August 4, 2017

Subject: NRDC Comments on ENERGY STAR Computers Version 7.0 Draft 1 Specification

Figure 1 – Distribution of memory configurations of products offered for sale, July 2017

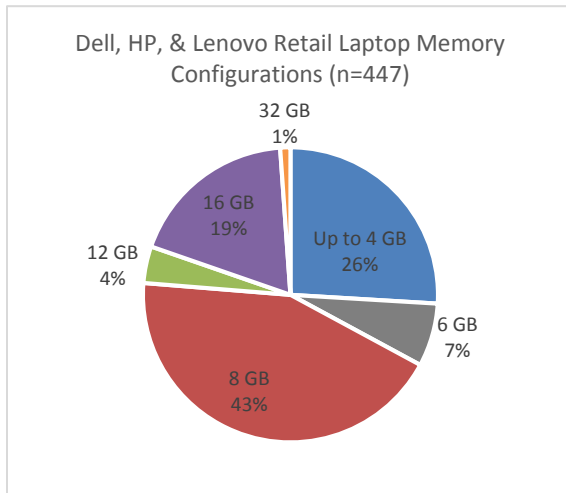
This issue is compounded by the fact that ENERGY STAR requires testing and reporting only the product configuration that represents the worst-case power consumption for each product family. This is likely to be products with the maximum amount of memory, which are getting outsized memory adders.

In fact, an analysis of major online retailers by Xergy Consulting clearly shows the discrepancy between the QPL and the market: more than three quarters of configurations offered for sale in July 2017 have 8GB memory or less (Figure 1), whereas these only represent one third of 2016-2017 configurations in the QPL (Figure 2).

- 1) Revise the memory adder structure and levels to better represent actual energy use by higher memory configuration, either by setting levels by DIMM as proposed by the CA IOUs, or if sticking to a capacity-driven adder, using **0.4 kWh/GB up to 8GB, and 0.15 kWh/GB above 8GB** in line with CEC's adder; And
- 2) **Adopt a 2-configuration testing and reporting requirement**, like the 4-configuration requirement for servers: for computers, this could be most typical model and worst-case power model. This should apply to both desktops and laptops and would improve the quality of the dataset for market analysis and future spec revisions, and would also provide greater transparency by ensuring that the most commonly-sold models are represented in the QPL.

Figure 2 – Distribution of memory configurations in ENERGY STAR QPL (2016-2017)

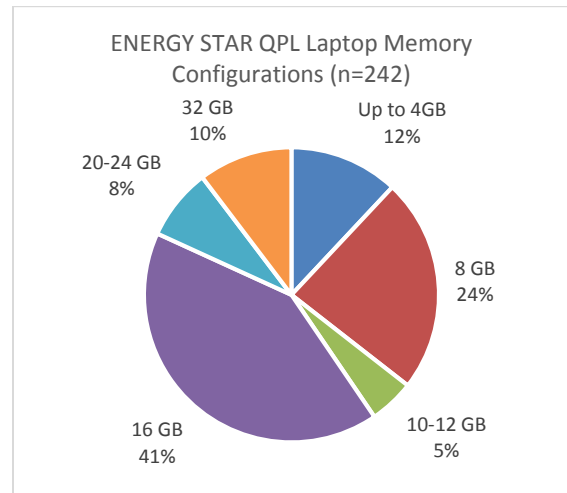
While this may not be a certification issue because EPA makes it clear that “manufacturers continue to be held accountable for any efficiency claims made about their products, including those not tested or for which data were not reported”, the QPL provides a skewed picture of the energy use and compliance margin of typical products, which does not facilitate a data-driven approach to setting base allowances and adders.

Figure 3 – Impact of Display Brightness on System Idle Power Demand

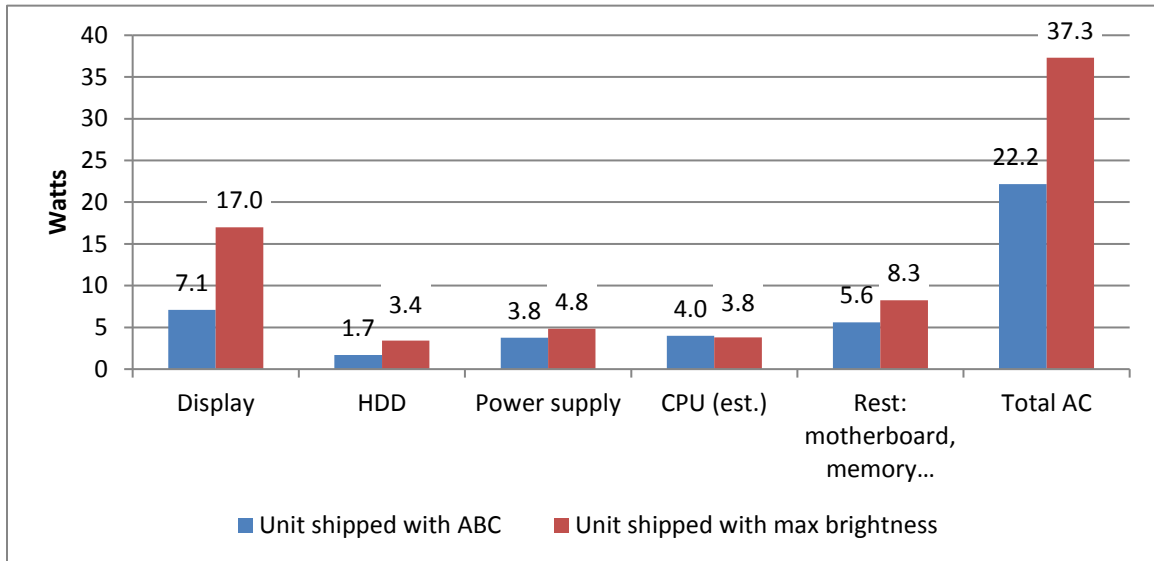
As part of the CEC rulemaking, NRDC and Aggios tested two all-in-one computers with comparable specifications (21.5-inch displays with same resolution and both using IPS technology, and similar computing performance).⁴ Both displays were responsible for a large share of system idle power demand (40 and 50 percent). However, one display was shipped with auto-brightness control (ABC) enabled, while the other was shipped with maximum brightness settings. The latter drew 2.4x the power of the former and was responsible for the majority of the difference in short idle power demand between the two computers as shown in Figure 3.

This difference was not captured by the test procedure because both computers were recalibrated and tested at the same brightness. Not only is this not representative of real-world energy use, but it also fails to reward units shipped with ABC enabled and to penalize units shipped with max brightness.

Recommendation regarding display brightness: One approach would be to test as shipped, with a minimum brightness level to avoid an incentive to ship with very low brightness just to qualify for ENERGY STAR.

If ABC is enabled as shipped, and is sufficiently persistent (does not get disabled through unrelated settings changes, per the TV test procedure), it should remain enabled and be tested in realistic lighting conditions to be defined.
